MEMORANDUM

To: Robert Grosvenor, Custer Gallatin National Forest; Minerals Administrator/AML Coordinator; submitted to: <https://www.fs.usda.gov/project/?project=61385>
From: Ann Maest, PhD; Buka Environmental
Date: 15 July 2022
Re: Scoping comments for Stillwater Mining Company, East Boulder Mine Amendment 004 Expansion EIS

Figure 1. Infiltration locations in Lower Lewis Gulch, 2015. The blue triangles indicate locations where infiltration of surface water was measured in Lower Lewis Gulch.

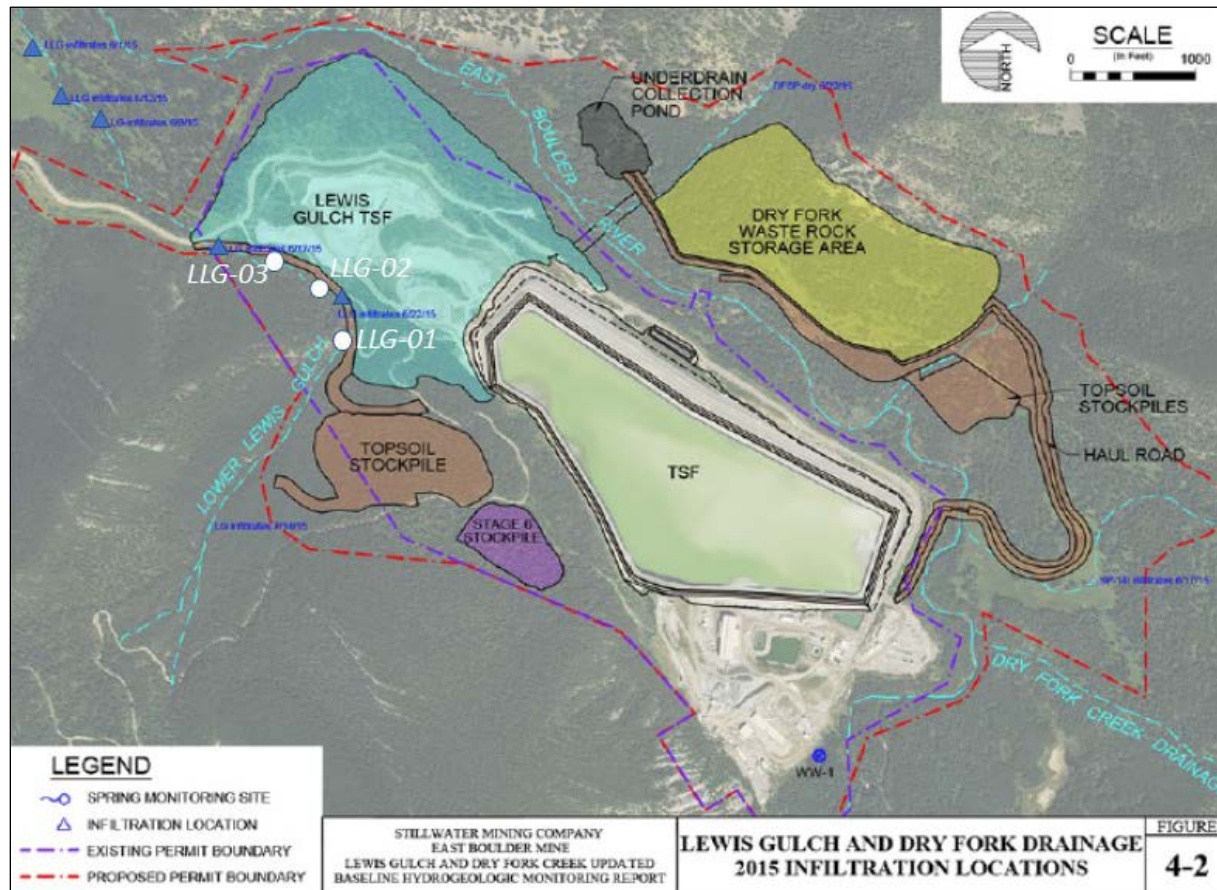
During synoptic sampling in 2015 and 2016, a large amount of surface water in Lower Lewis Gulch was found to infiltrate to groundwater, as shown in Figure 1 for 2015. Two areas of observed infiltration are on the southwestern side of the proposed Lewis Gulch TSF. Approximately 300 to 600 gpm of stream flow infiltrated to groundwater between LLG-1 and LLG-2; about 1,800 to 2,400 gpm of stream flow infiltrated to groundwater between LLG-2 and LLG-3; and about 2,100 to 3,300 gpm infiltrated to groundwater below LLG-3. The estimated total infiltration of Lower Lewis Gulch surface water to groundwater in 2015 is ~25 million cubic feet or ~190 million gallons (Hydrometrics, 2021, p. 403). The implications of this infiltration to the stability of the proposed Lewis Gulch TSF are not discussed, but it is possible that surface water could infiltrate and pool under the proposed expanded TSF – especially between LLG-01 and where the Lewis Gulch TSF covers the stream downstream of LLG-03 (see Figure 1). Figure 4-6 in Hydrometrics (2021) shows groundwater elevations in screened wells are substantially below the base of the proposed TSF. But could water infiltrating from Lower Lewis Gulch (see above) move through the vadose zone and underneath the TSF as perched groundwater? Perched groundwater would not be evident in a monitoring well that is screened at certain depths. As part of preparation for the Draft EIS, a geophysical study should be conducted during snowmelt to determine if water is moving through the vadose zone from Lower Lewis Gulch to under the proposed TSF.

- The implications of the large amount of surface water infiltration to groundwater on the southwestern side of the proposed Lewis Gulch TSF to the stability of the impoundment need to be better understood. It is possible that surface water could infiltrate and pool under the proposed expanded TSF – especially between LLG-01 and where the Lewis Gulch TSF covers the stream downstream of LLG-03. As part of preparation for the Draft EIS, a geophysical study should be conducted during snowmelt to determine if water is moving through the vadose zone from Lower Lewis Gulch to underneath the proposed TSF.

Figure 2. Sulfate and pH trends in Stillwater Mine groundwater. Upgradient wells are dashed.

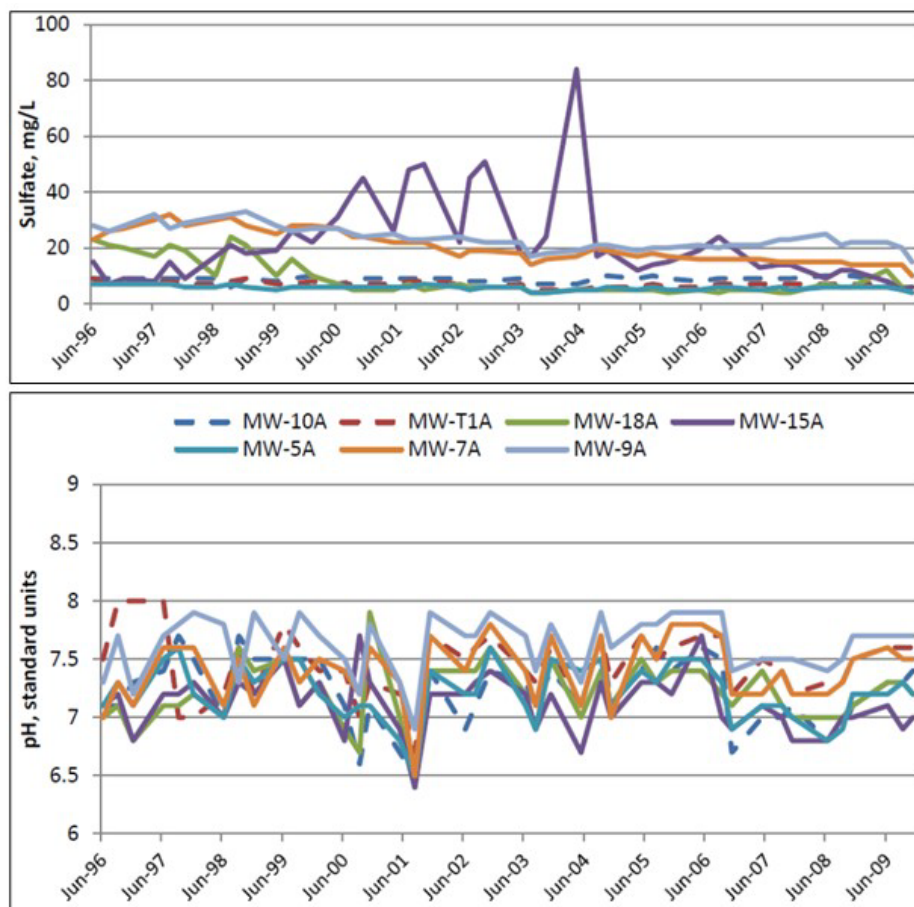
As shown in Figure 2, sulfate concentrations were elevated in monitoring well MW-15A, which is downgradient of the Stillwater Valley Ranch percolation ponds and the former East Side center pivot north land application and disposal (LAD) system area (MDEQ and USFS, 2012, Appendix E). The intermittent sulfate peaks likely resulted from seasonal disposal of mine water at the LAD and use of the Stillwater Valley Ranch percolation ponds while the Hertzler Rand LAD storage pond was being constructed. Concentrations since decreased to close to background values. The pH in MW-15A is lowest of those shown in Figure 2 below. The elevated sulfate concentrations and somewhat depressed pH values suggest that sulfide minerals are oxidizing and could eventually form acid drainage. As noted above, neither the treatment system currently in use nor the proposed system will remove sulfate; the RO system will remove sulfate, but it is only kept as a back-up system, and discharge to Outfalls 001 or 002 could increase concentrations of sulfate and other constituents in groundwater and surface water, including dissolved metals. As noted in the 2009 TMDL for the Boulder River, permitted point source discharges from the East

- The elevated concentrations of sulfate in adit and process water indicate that sulfide minerals in the ore and wastes are oxidizing. The groundwater well with occasional sulfate peaks at the Stillwater Mine (MW-15A) also had the lowest pH values, suggesting that acid drainage could be forming very slowly at the site. The potential for very long-term formation of acid drainage should be evaluated in the Draft EIS.
